## HISTORIC AND DESIGN REVIEW COMMISSION

**HDRC CASE NO:** 2020-201  
**COMMON NAME:** 335 TRAIL  
**LEGAL DESCRIPTION:** NCB 6078 BLK 2 LOTS 9 THRU 14 & 17 THRU 20  
**ZONING:** MF-33, RIO-1, H  
**CITY COUNCIL DIST.:** 1  
**DISTRICT:** River Road Historic District  
**TYPE OF WORK:** Consideration and action of an application for a multi-unit residential development:

Item B: The applicant is requesting a Certificate of Appropriateness for approval to construct a multi-unit residential development (23 units) on the vacant lot located at 335 Trail. The property features lots that are located within the River Improvement Overlay only, as well as those that are located within both the River Improvement Overlay and the River Road Historic District. The applicant has proposed for the residential structures to feature two and three stories in height. Access to the site will be provided from Trail Street and Huisache Street. A revised parking proposal is included in this request.

- Increased setbacks on Trail Street

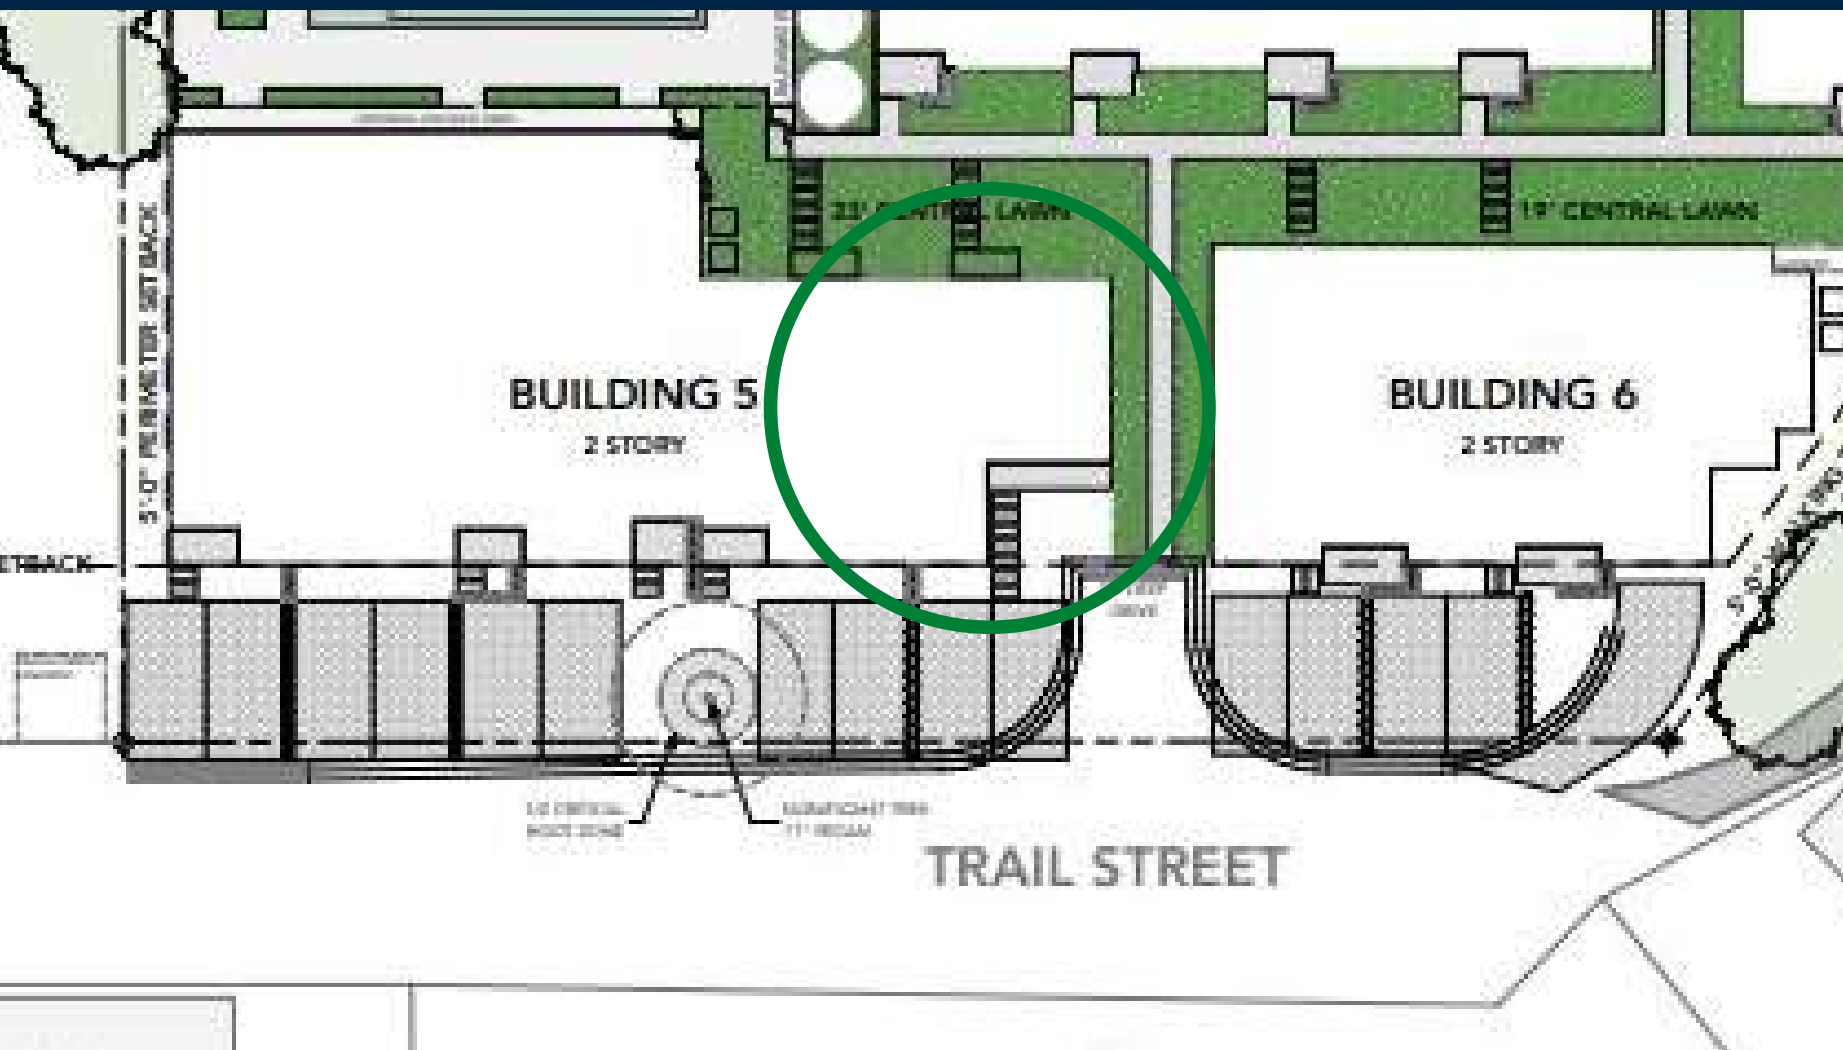
*Increased setback from 18 feet to 20 feet*
